RE: Open Newcastle Submission on DA 2019/00061

Thank you for the opportunity to make a submission in relation to DA 2019/0006. This submission is from Open Newcastle Inc, a local residents group. We wish to register our strong objection to the development proposed for 11-17 Mosbri Crescent the Hill.

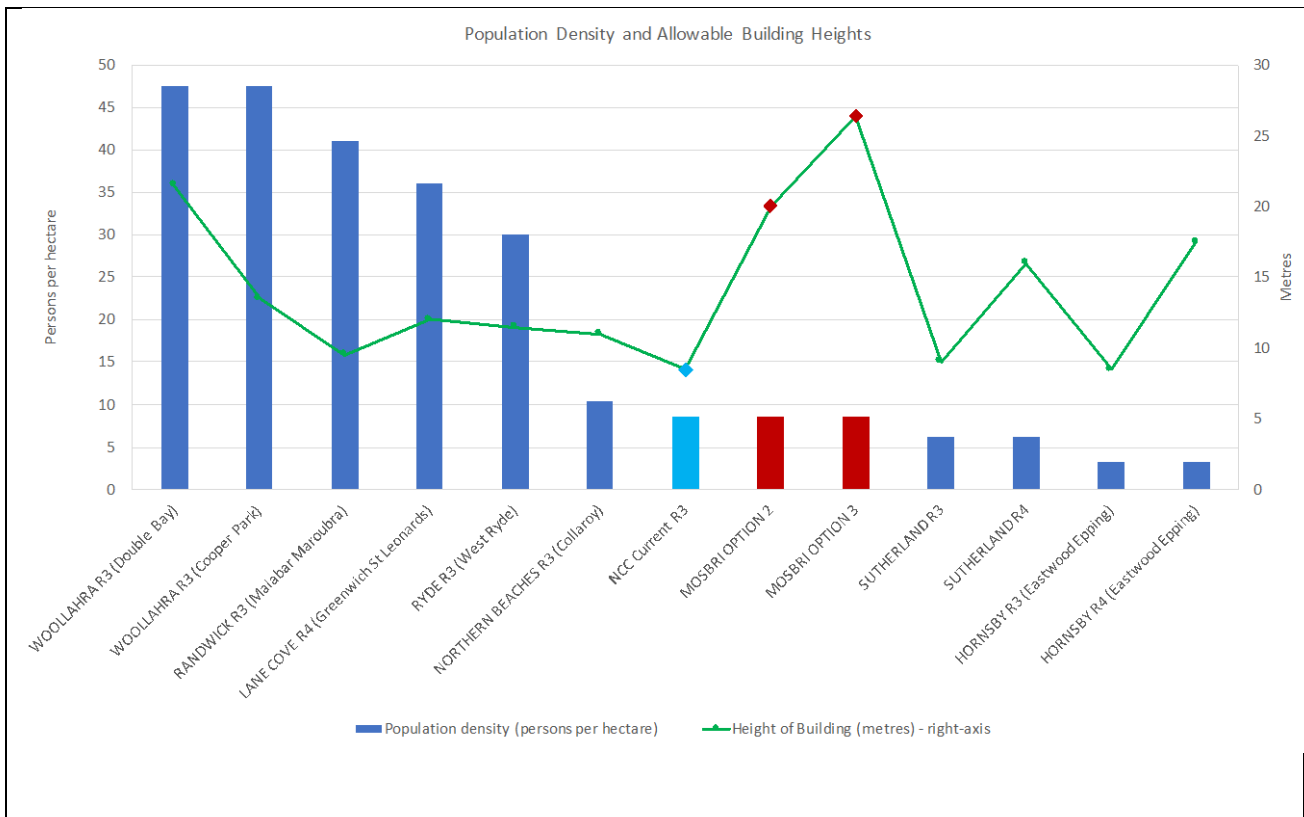
The population increase represented in the DA is unprecedented and unplanned for. The Planning Proposal (which the applicant refers to in the DA documentation) associated with the recent rezoning of the site notes that areas adjoining the site are generally considered appropriately zoned R2 Low Density and are unlikely to be redeveloped to significant scale variation. The DA, if approved will produce a site that is completely incongruous and will remain so into the future.

The increase in population levels on this site reflect the poor outcome of the planning proposal. The population increase is facilitated by inappropriate HOBs and FSRs and will likely have unintended impacts on the amenity of nearby development. The graph below illustrates the source of risk. The bars indicate population density in a number of Local Government Areas (LGAs). The line indicates allowable HOBs in the relative LGA. Mosbri Option 1 represents the standard controls for an R3 medium density zoning. Mosbri Option 2 and Option 3 reflect HOBs of 20m and 26m respectively. These reflect heights considered in the planning proposal phase, which the DA exceeds. The graph below demonstrates that the HOBs on 11-17 Mosbri Crescent exceed those in LGAs with five times the population density. The locality is not at prepared for development of this intensity and the related population growth.
